Permit Number: 081422

This is to certify that 16-18 WENTWORTH ST INC property  
 has permission to interior renovations, removal of floor joists, separation of floor joists, repair of front back foundation, plumbing electric and ne  
 AT 112 SHERIDAN ST C 013 J011001

**City of Portland, Maine - Building or Use Permit Application**

RE: 112 Sheridan Street – 013-J-011 – R-6 Residential Zone

PLUT PLAN - 112 SHENDAW ST.

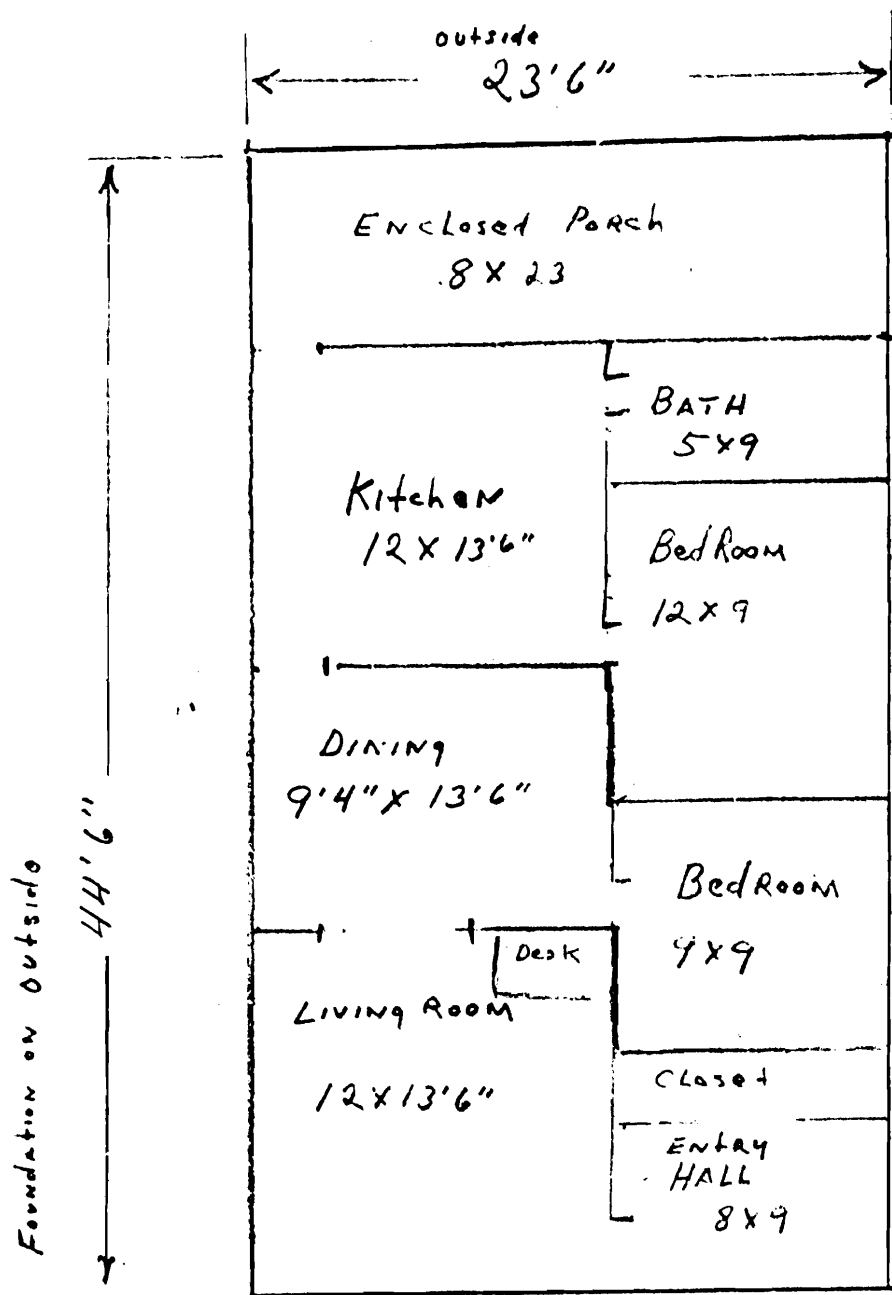
As you know, during the review of a recent permit application (#08-1422) to do interior and exterior renovations, my research showed that the rear, second floor 4' x 8' balcony was never properly permitted with a required permit. It is not a "legal" structure because it has not been properly permitted. Therefore, in an effort to move along your permit and allow interior alterations not affected by the rear balcony, you agreed to remove the request to do work on the rear balcony. Now, because of a recently performed survey, it has come to your attention that the rear balcony (and perhaps part of your first floor rear porch) extends over the rear property line onto an abutting property.

Please note that if you can not show right title and interest on the rear 4' x 8' balcony, it will be necessary to remove that structure in its entirety. This office can not approve the building of a structure on an abutter's property. For documentation, you will need a permit from this office to remove the rear balcony.

It will be necessary to notify this office within 30 days as to what specific action(s) you will be taking to resolve this illegal balcony.
